Staff Report

To: Salt Lake City Planning Commission
From: Meagan Booth, Principal Planner
385-395-9035, meagan.booth@slcgov.com
Date: October 15, 2021
Re: DeWitt Design Review@ 352 S 500 E - PLNPCM2021-00649

DESIGN REVIEW

SHEET NAME:
**ARCHITECTURAL SITE
PLAN**

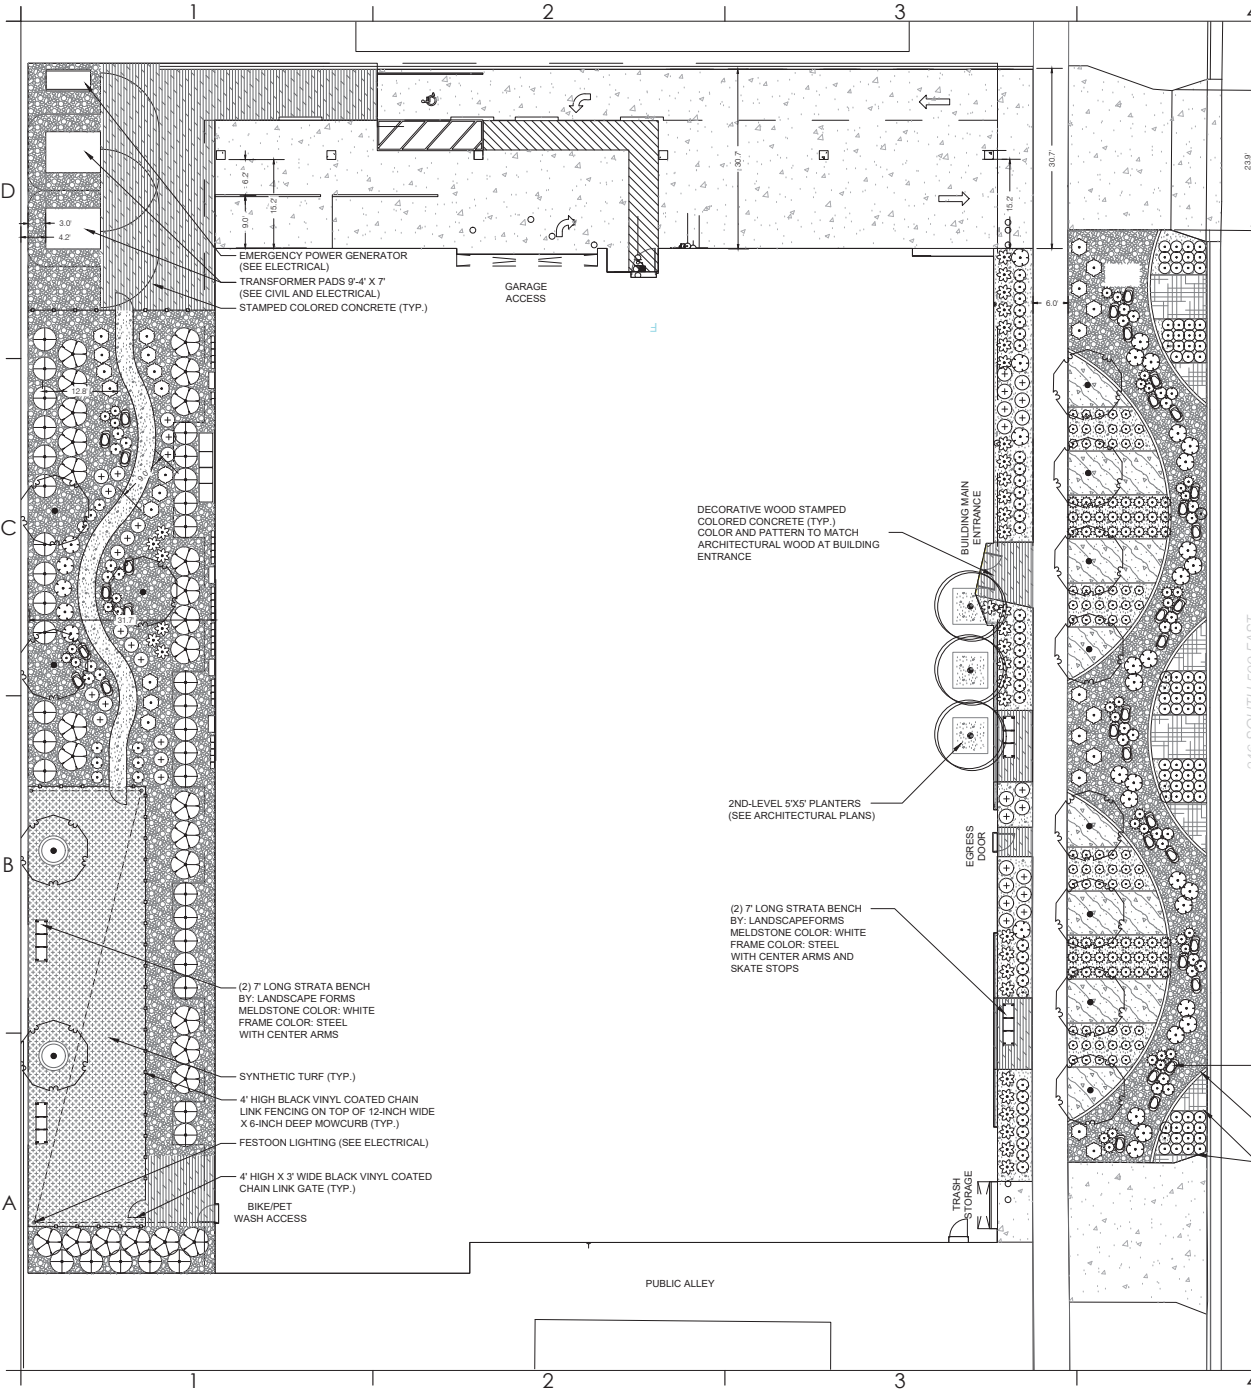
A public comment was received about the shared drive on the south, with worries about encroachment into the easement. An ALTA survey with a legal description was submitted by the developer. The project does not use the shared drive in any way. Through the duration of the project there should be zero encroachment into the public easement. Please see the ALTA survey attached.

SHEET NAME:
LEVEL 1 FLOOR PLAN

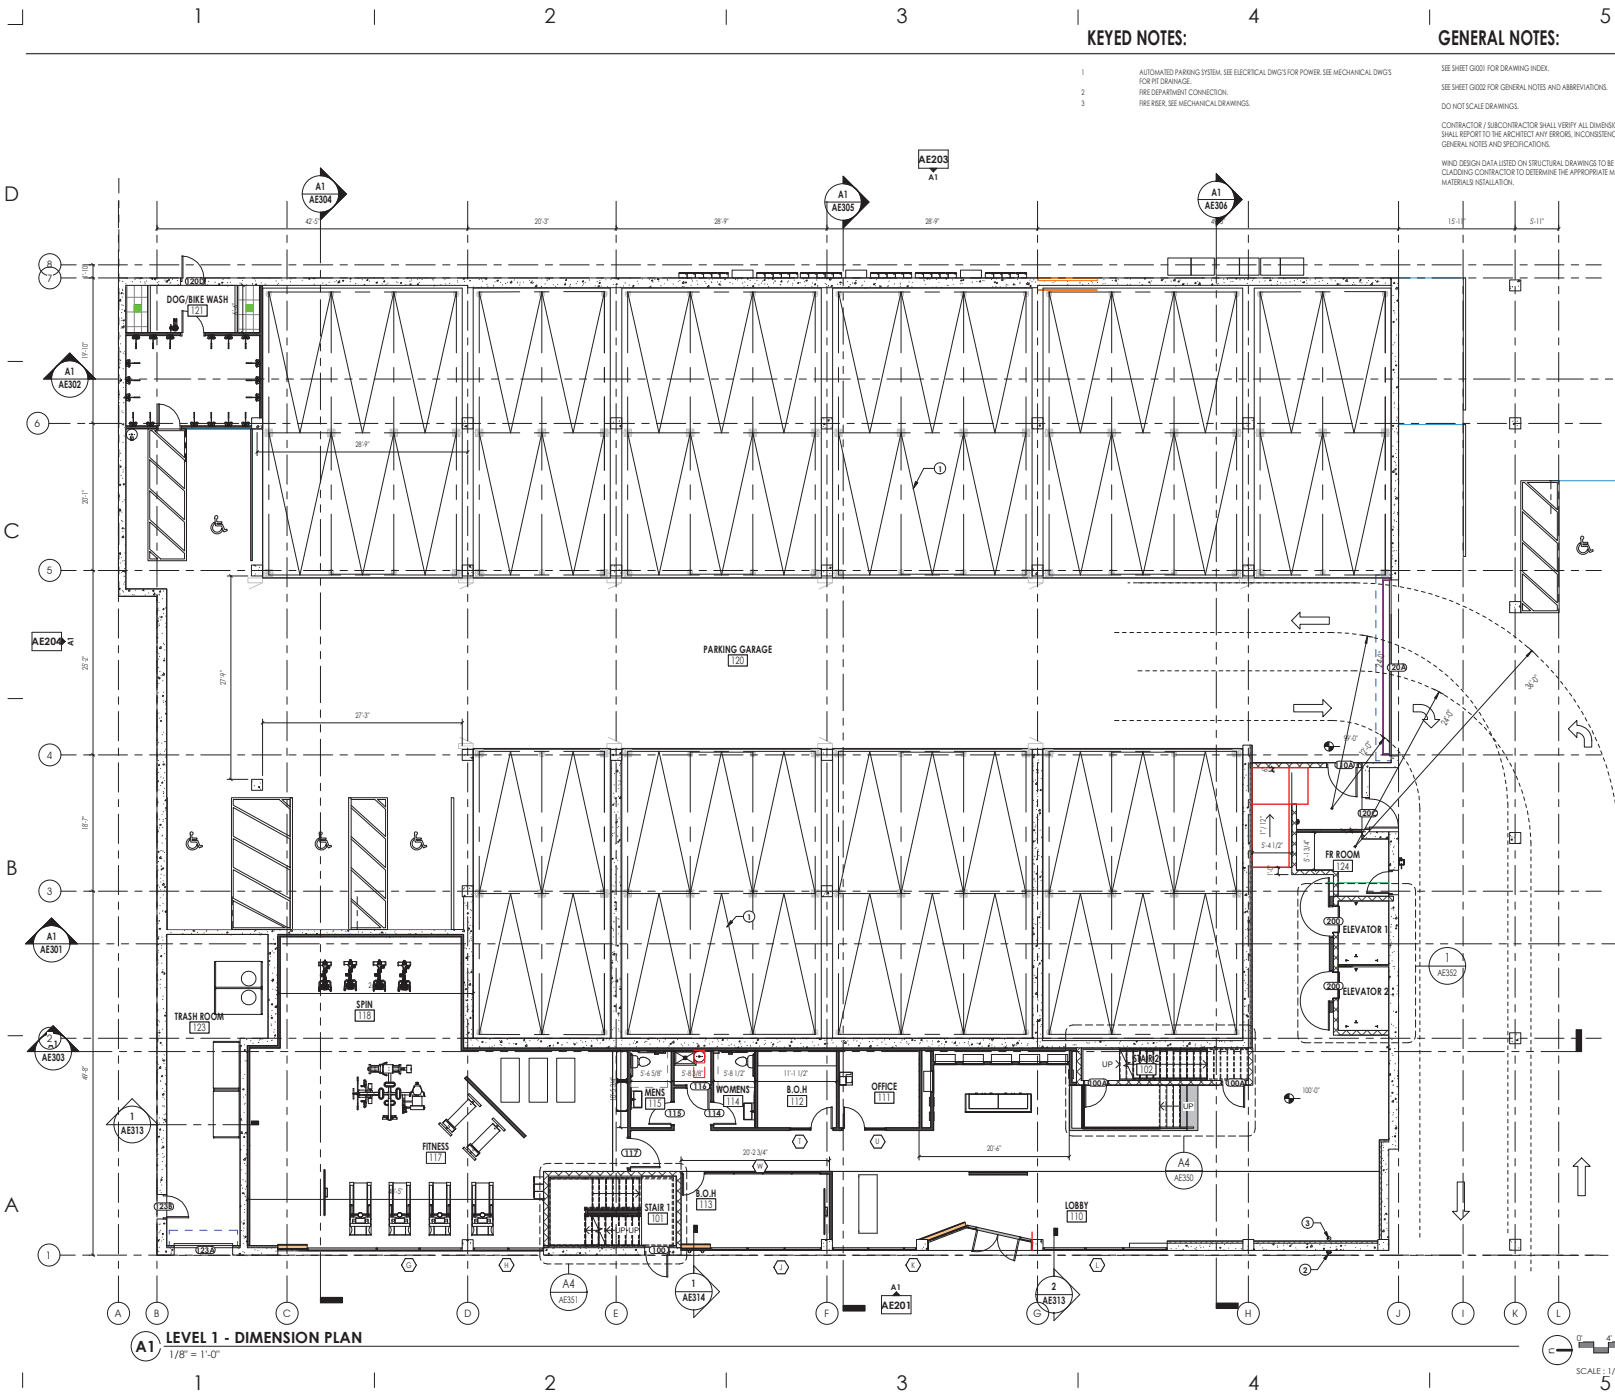
3. Bike parking: The thing that gets me hung up on this one is that the ordinance states that the location of the bicycle parking shall include a pathway (or sidewalk) that is connected to the right-of-way and is clearly separated from the parking lot and drive lanes. In this case, the bikers would be riding down the driveway, through the parking area and into the bike room, which doesn't meet the intent of the ordinance. I like the fact that they are providing a room for bike storage and especially because some of these units are small and space is at a premium. would suggest that they install four (4) bike racks (8 bike spaces) in the front of the building meeting all the specific bike rack location standards; this would satisfy their bike parking requirement. They can keep the storage room with bike racks, but maybe just call it "storage".

ajc response: We suggest adding a 4'-0" door from the public alley on the south property line to access the indoor bike storage. Updated Level 1 floor plan and site plan attached.

Grading at the public alley does not work with the Level 1 indoor bicycle storage finished floor grading. The access door cannot be provided. Hence in addition to bicycle storage at Level 1, we propose to add secured storage at the basement level with 6 additional parking stalls (4 stalls are required – 50%). The basement bicycle storage will be accessible from the public right-of-way through the building lobby and elevator.
